## HISTORIC AND DESIGN REVIEW COMMISSION

December 06, 2017

**HDRC CASE NO:** 2017-522  
**ADDRESS:** 401 E LOCUST  
**LEGAL DESCRIPTION:** NCB 1737 BLK 6 LOT 7 (CARLA HILLS)  
**ZONING:** MF-33  
**CITY COUNCIL DIST.:** 1  
**DISTRICT:** Tobin Hill Historic District  
**APPLICANT:** Varco Builder of Texas LLC  
**OWNER:** Brian Correa  
**TYPE OF WORK:** Install carport, rear deck awning, and wood front yard fence  
**APPLICATION RECEIVED:** November 9, 2017  
**60-DAY REVIEW:** January 8, 2018  
**REQUEST:**

The applicant is requesting a Certificate of Appropriateness for approval to:

BRIAN'S HOUSE  
401 E. LOCUST

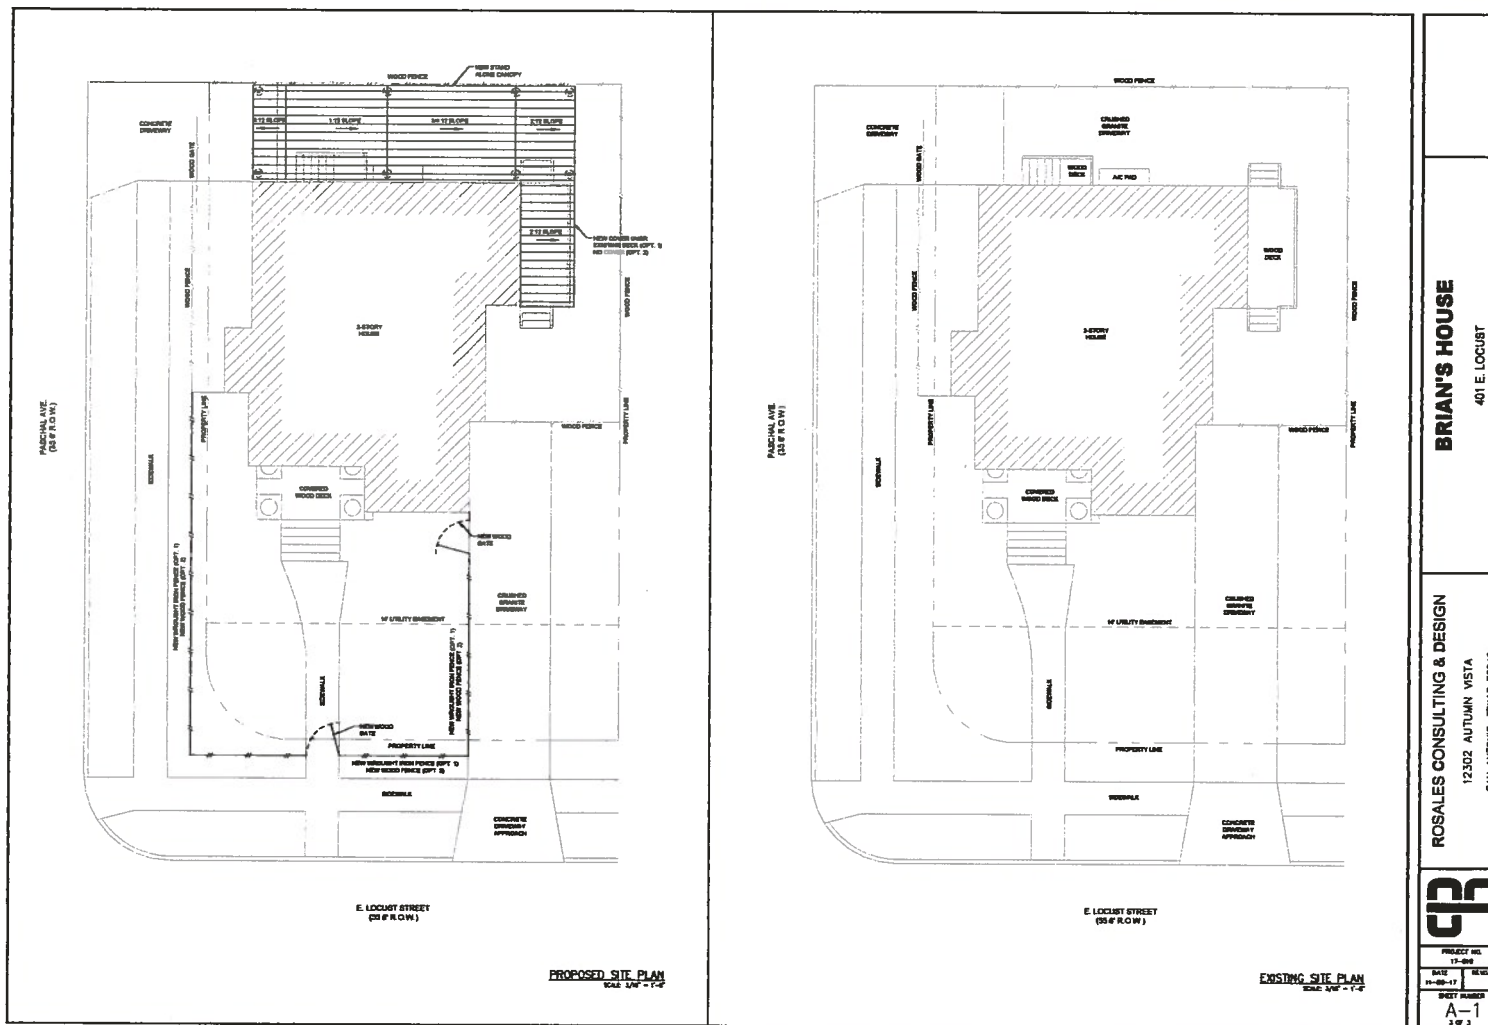
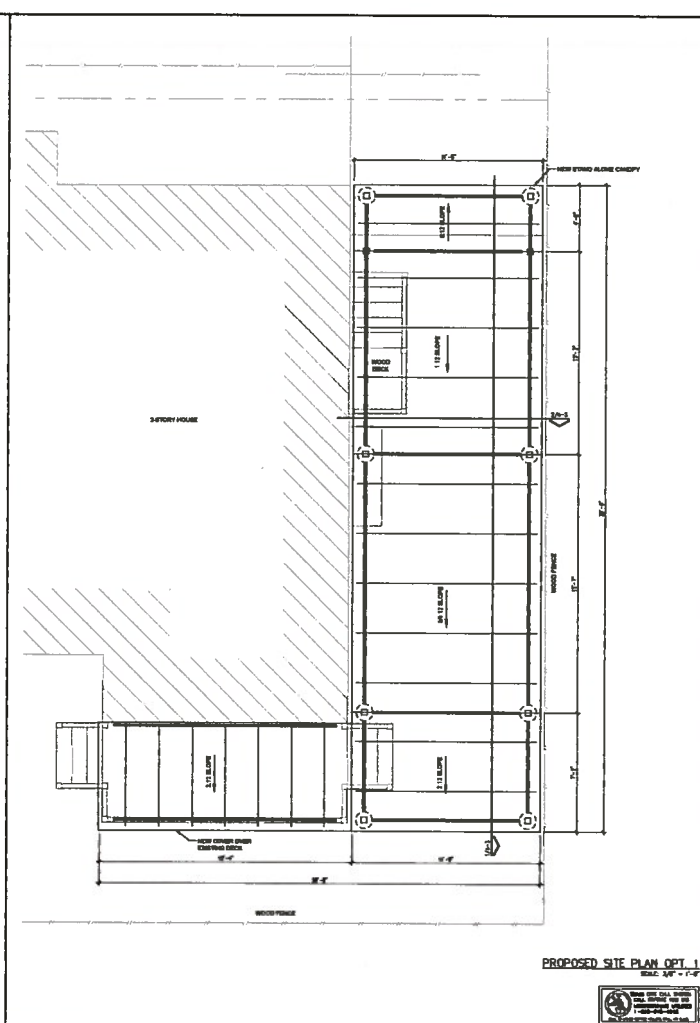
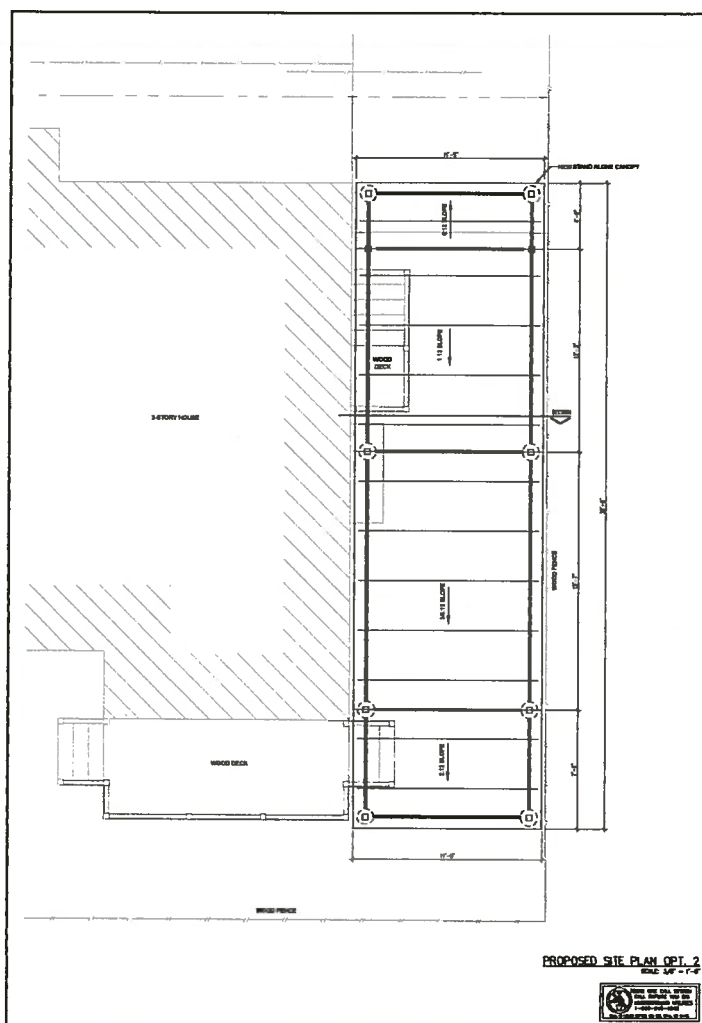
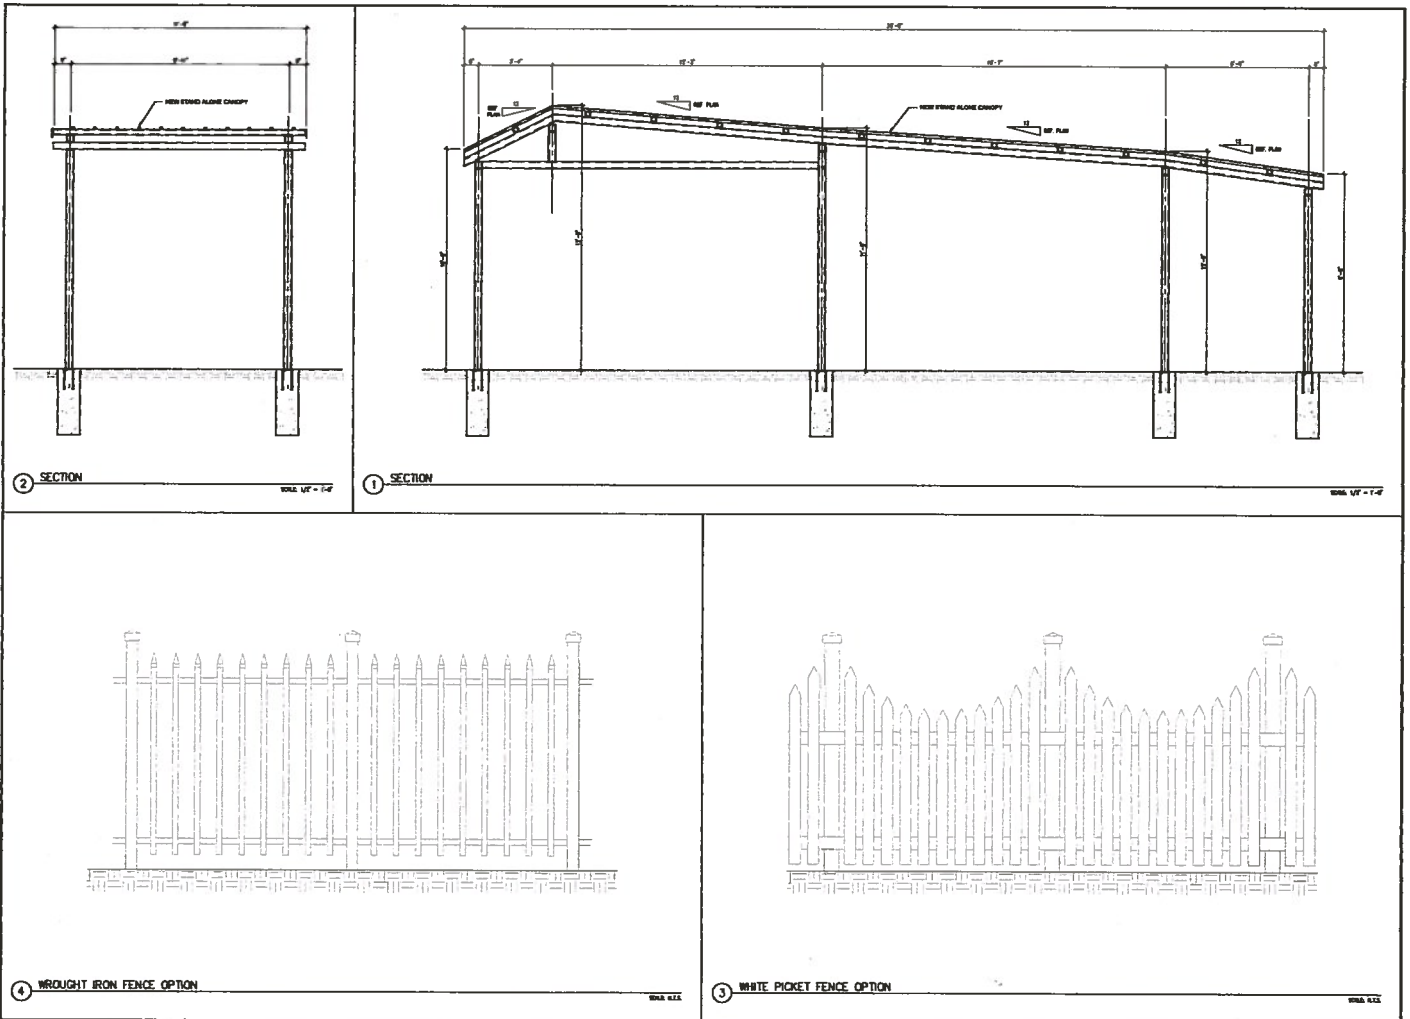
- c. CARPORT – The applicant has proposed to construct a new carport adjacent to the historic structure for entry from cross street Paschal. The proposed carport features 11’5” in width, 39’ in depth, and 9’ to 12’ in height. The proposed carport features cedar wrapped metal columns and a low sloping metal roof to match the historic structure. While staff finds the proposed carport’s construction materials and setback from the Paschal Street right-of-way appropriate, the proposed overall footprint and location of the carport is not consistent with Guidelines 5.A.i (“subordinate to the historic structure”).

- 1. Staff does not recommend approval of fence installation based on findings b.
- 2. Staff recommends approval of the construction of a new carport with the stipulation that it is setback farther away from the primary historic structure based on findings c.
